Plan Commission

Monday, August 22, 2022

SUBJECT: Consideration and possible action on an amended Precise Implementation Plan for a proposed drive-in or convenience food establishment at 1610 Lawrence DR (Parcel WD-D0015-2-1). *

- ITEM 5:** Consideration and possible action on an amended Precise Implementation Plan for a proposed drive-in or convenience food establishment at 1610 Lawrence DR (Parcel WD-D0015-2-1). *

SITE PLAN

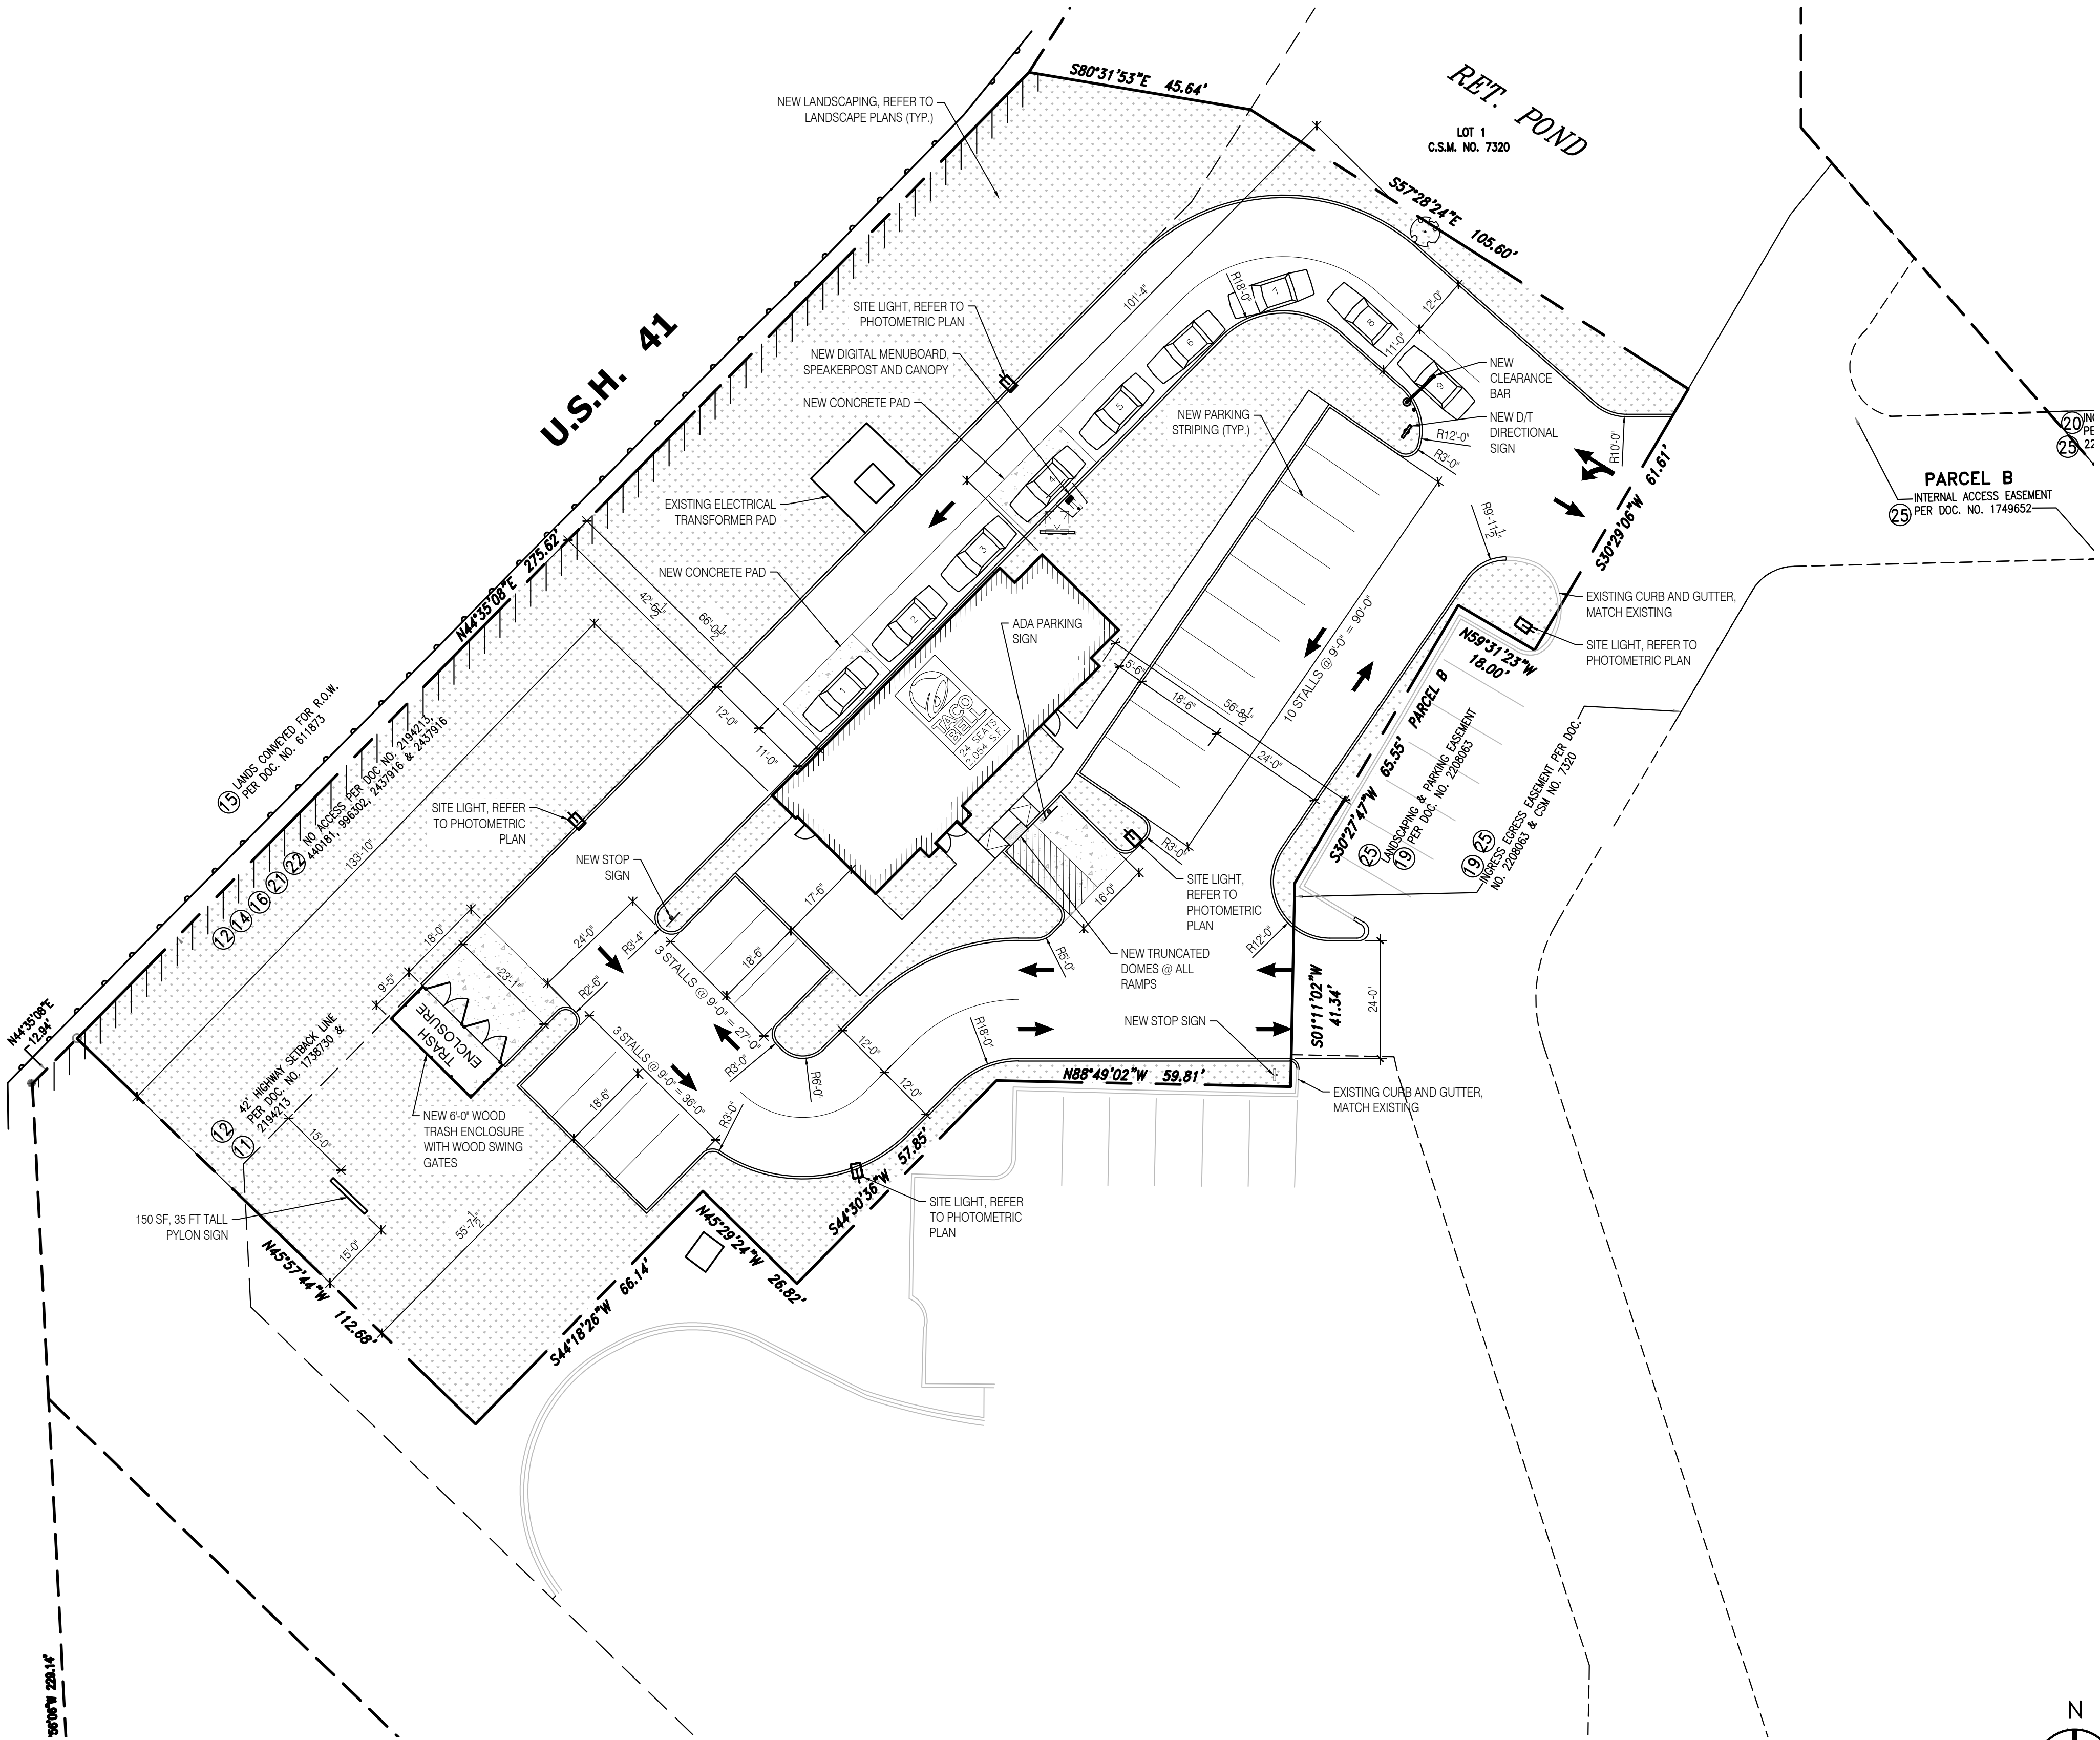
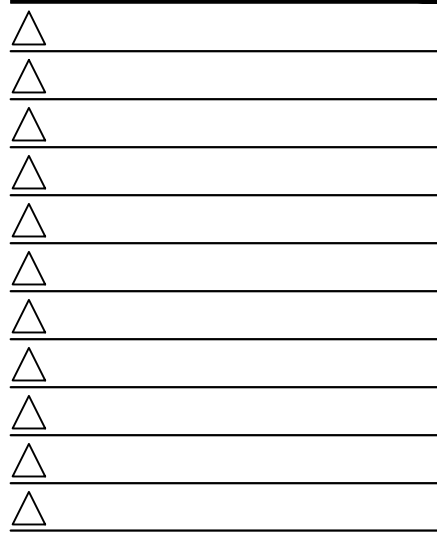
- 3. The site plan has four wall signs and only one wall sign is permitted per street frontage due to having only one street frontage on I-41. Remove excess signage and identify the size (length, width, square footage) within the site plan and describe each sign clearly within the PIP narrative. There may be potential options (not guaranteed) for a second wall sign, but the potential options require discussion with staff.
